**ON-SITE SEWAGE DISPOSAL SYSTEM  
HOWARD COUNTY HEALTH DEPARTMENT  
BUREAU OF ENVIRONMENTAL HEALTH**

SUBDIVISION: Clarksville Overlook LOT NUMBER: 21

ADDRESS: 6318 Kerne Ct PROPERTY OWNER: NVR Homes

**SITE & GRADING PLAN**  
FOR  
**CLARKSVILLE OVERLOOK**  
(A.K.A. MACBETH FARMS)

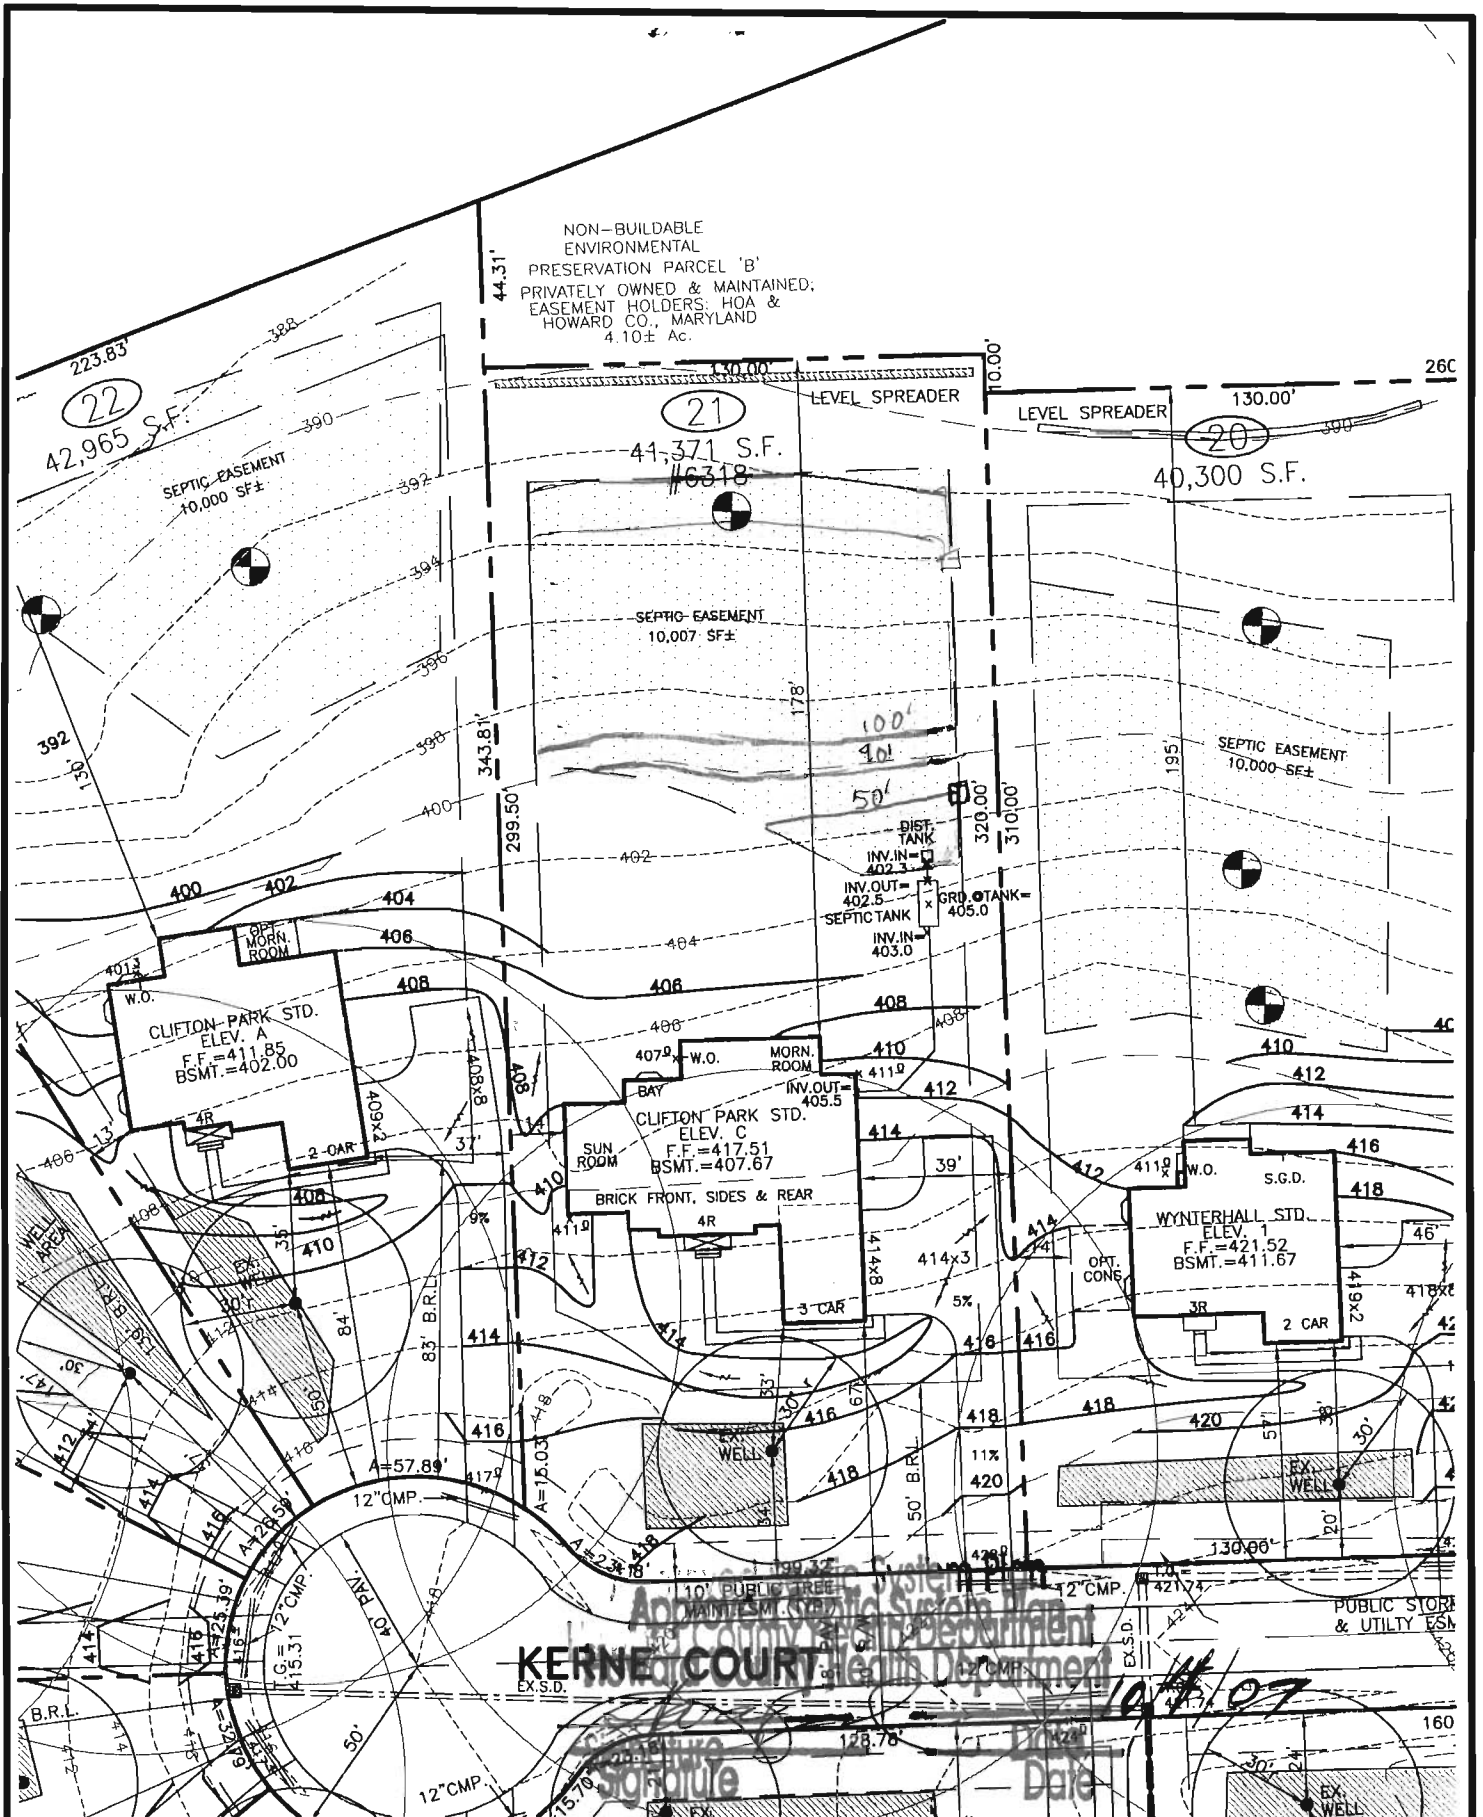
*Trenches 2' Wide  
Inlet 4', Bottom 7'  
50, 90' + 100' Trenches*

PRE-CONSTRUCTION 5/27/08 Contractor to install one short trench (level to be adjusted slightly higher) 50' or so and

INSTALLATION 2 long trenches just below 50' trench, totalling 240'. Set D box @ start of 1st trench. ST. placement as per B.P. plan. Call for insp. (KW) 5/28/08 Tank set

plumbing installed from house to tank. Top 50' trench installed. (KW) 5/29/08 Trenches complete. Middle trench

installed slightly further down will due to contour. D box knocked. 50' trench level turned up ~ 92%. OK to

Back fill (KW)

**AS-BUILT FOUNDATION PLAN**  
MACBETH FARMS  
6318 KERNE COURT  
LOT #21  
FLAT M.D.R. NO. 18740  
5th ELECTION DISTRICT, HOWARD COUNTY, MARYLAND

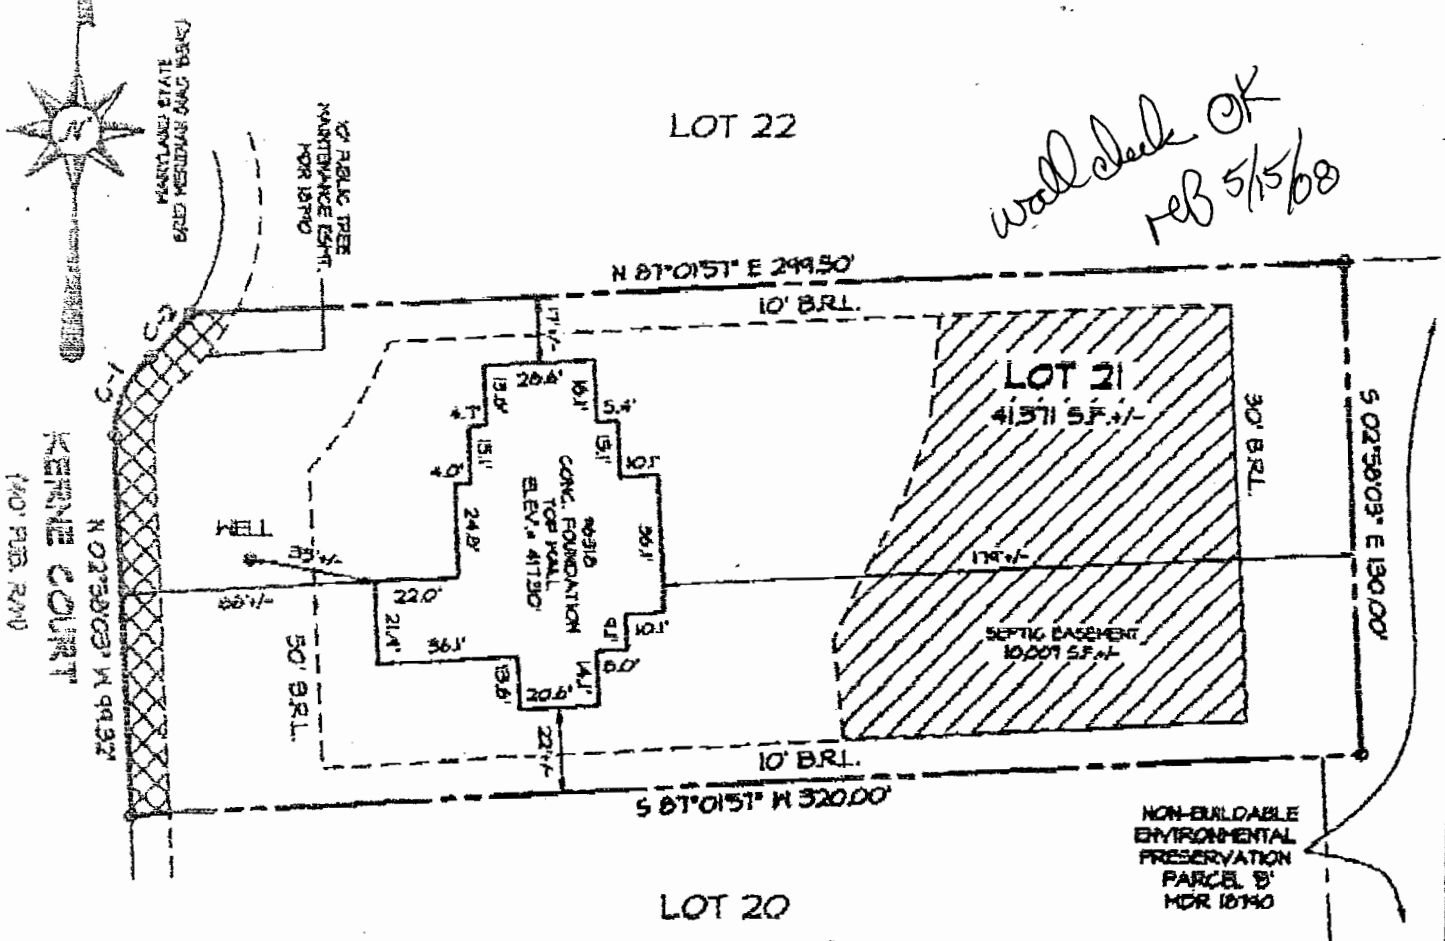
*Wall check OK  
Feb 5/15/08*
